# Town of Simsbury

**RE:** **Application ZC #24-07** of 34 Hopmeadow St. Realty Co, LLC, a site plan application to construct a +-15,100 sq. ft. child care center at 34 (aka 30 Hopmeadow St.) Hopmeadow Street (Assessor's Map E19, Block 117, Lot 001-1C) Simsbury, CT 06070, zone PAD.

**Subject:** **Engineering Comments – Childcare Facility (#30 Hopmeadow Street)**

### Site Plan Review Comments from Town Staff

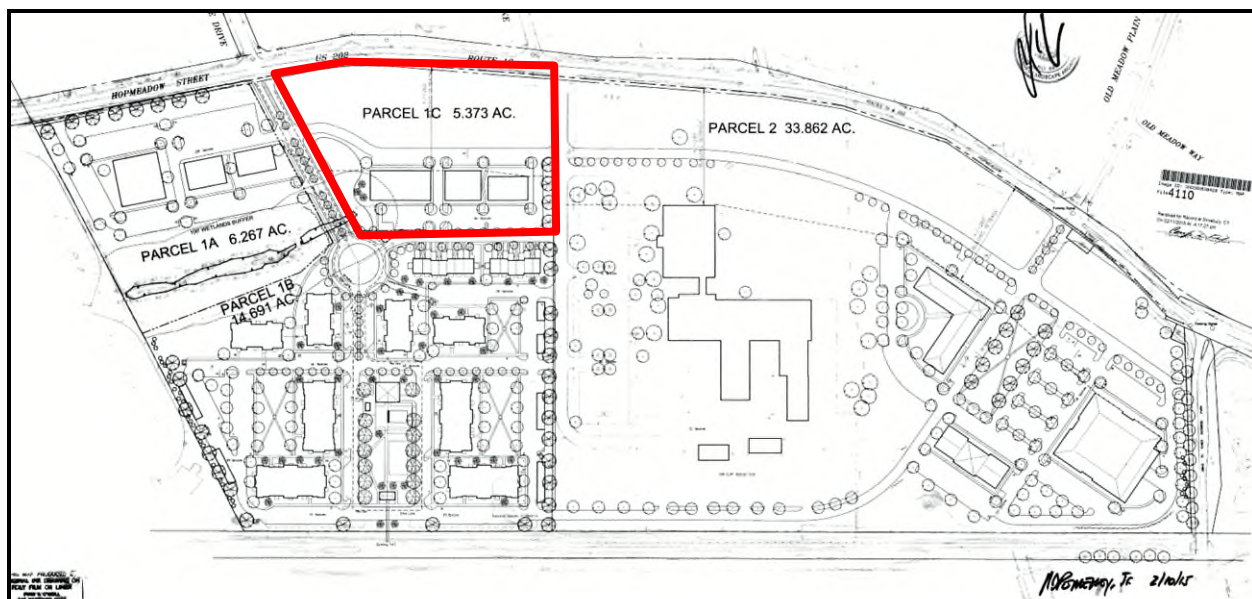
Town Engineer--The Town Engineer provided a great number of comments related to site design, particularly regarding the stormwater conveyances proposed. A number of other technical revisions are also requested. Once those revisions are received, Staff will provide an update to the Zoning Commission.

Planning Department--The Planning Department has also requested revisions, additions, and clarifications to the application, including additional landscaping, a reduction in total parking spaces, and an extension of onsite pedestrian connections.
